RESOLUTION NO. 2022-07

A RESOLUTION OF THE BOARD OF SUPERVISORS OF NEW BRITAIN TOWNSHIP GRANTING PRELIMINARY/FINAL LAND DEVELOPMENT APPROVAL TO BUTLER PIKE PROPERTIES, LP, FOR THE LAND DEVELOPMENT PLANS FOR BUTLER PIKE PROPERTIES, LP, PREPARED BY HOLMES CUNNINGHAM, LLC, DATED NOVEMBER 30, 2021, CONSISTING OF 21 SHEETS, WHICH PROPOSE THE CONSTRUCTION OF TWO BUILDINGS FOR RESIDENTIAL AND COMMERCIAL PURPOSES.

Reference: County Builders, Inc. - Preliminary LD Plan Review 1
West Butler Avenue
TMP # 26-005-023

Subject: BCPC #9134-C
Preliminary Plan of Land Development for Butler Avenue Mixed Use
TMP #26-5-23
Applicant: Butler Pike Properties, LP
Owner: Same
Plan Dated: November 30, 2021
Date Received: December 22, 2021

DATE: 07/13
 TIME: 10:00 AM
 PROJECT: BUTLER AVENUE PROPERTY
 DRAWING NO: CP-6

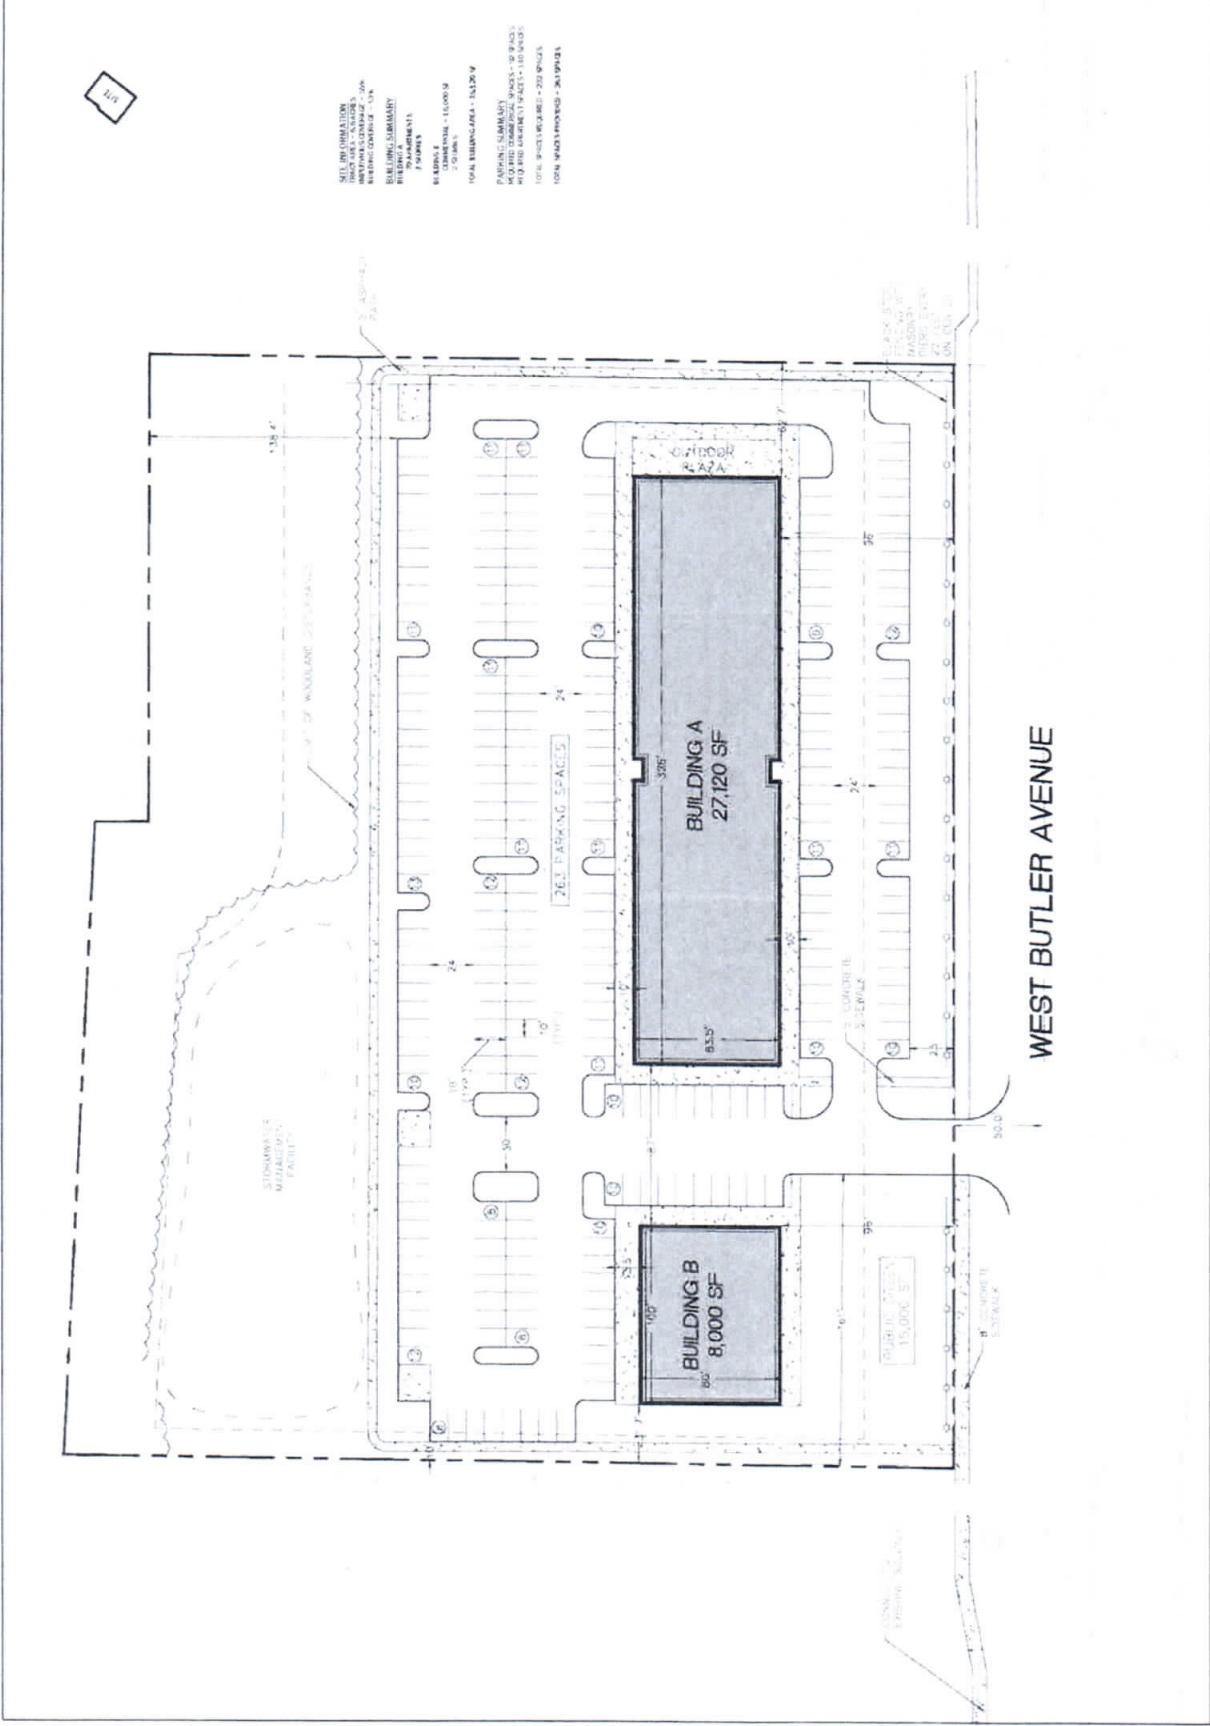
1. Stipulated Agreement #5 – The Property Owner shall be entitled to land development approval for the residential and commercial development of the Property for the apartment and commercial use(s) upon the filing of a land development plan in substantial conformity with the "Settlement Plan". We note the following deviations from the "Settlement Plan":

- a. Building B is shown as 11,500 SF on the Preliminary Plan as compared to the 8,000-SF building on the Settlement Plan. We note that the parking layout has been revised from the Settlement Plan to eliminate 10 spaces along the rear of Building B, as well as 2 spaces along the main access driveway. This results in 19 of the 66 parking spaces required for Building B being provided on the opposite side of the main access driveway.

- c. Based on the Apartment and Medical Office uses proposed, 206 spaces are required. The total number of parking spaces was reduced from 263 on the Settlement Plan to 247 spaces. The layout shall be revised to provide the number of parking spaces as depicted on the Settlement Plan.

- d. The asphalt trail has been adjusted at the rear of the property through the woodlands and around the proposed stormwater facility.
 - e. The sidewalk adjacent to the two buildings were shown as 10 feet wide on the Settlement Plan, where now a 5-foot walkway is proposed. However, where parking stalls are proposed adjacent to a sidewalk or walkway, the minimum width of the sidewalk or walkway shall be increased to a minimum width of six feet. (§22-708.2.F)
